Village of Arlington Heights Building & Life Safety Department

Subject: 2400 S Arlington Heights Rd. – Paragon Mechanical LUV Amendment – Amendment to LUV Ordinance #20-022

PC#: 2-010– Round 1

Project: Paragon Mechanical LUV Amendment – 2400 S. Arlington Heights Rd.
Amendment to LUV Ordinance #20-022

FLOOR PLAN
SCALE: 1/8" = 1'-0"

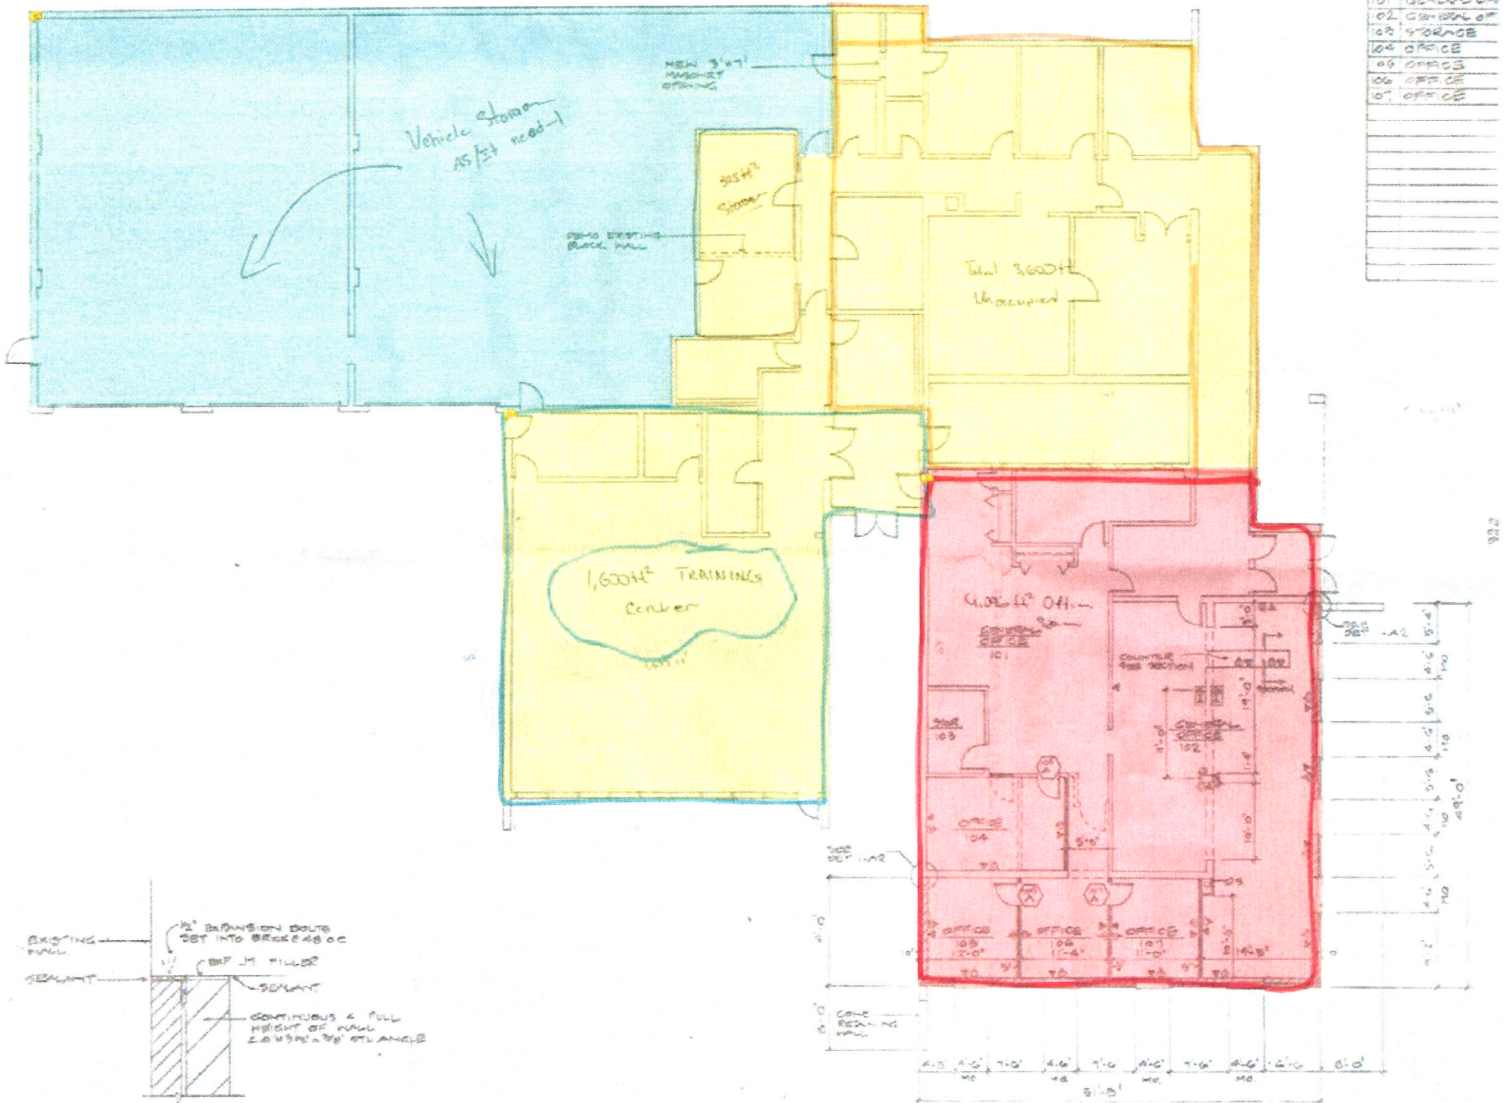
- **The variance requested is the minimum variance necessary to allow reasonable use of the property.**
9. In order to recalculate parking, please confirm the accuracy of the usage areas and sizes as depicted in the attached floorplan (the square footage's shown on the attached were derived from scaled measurements of the floorplan and should be close to 100% accurate). Additionally, please provide the following information:

- Garage/Vehicle Storage - 4,710 sq. ft.
- Materials/Miscellaneous Storage - 5,848 sq. ft.
- Office Area - 3,448 sq. ft.
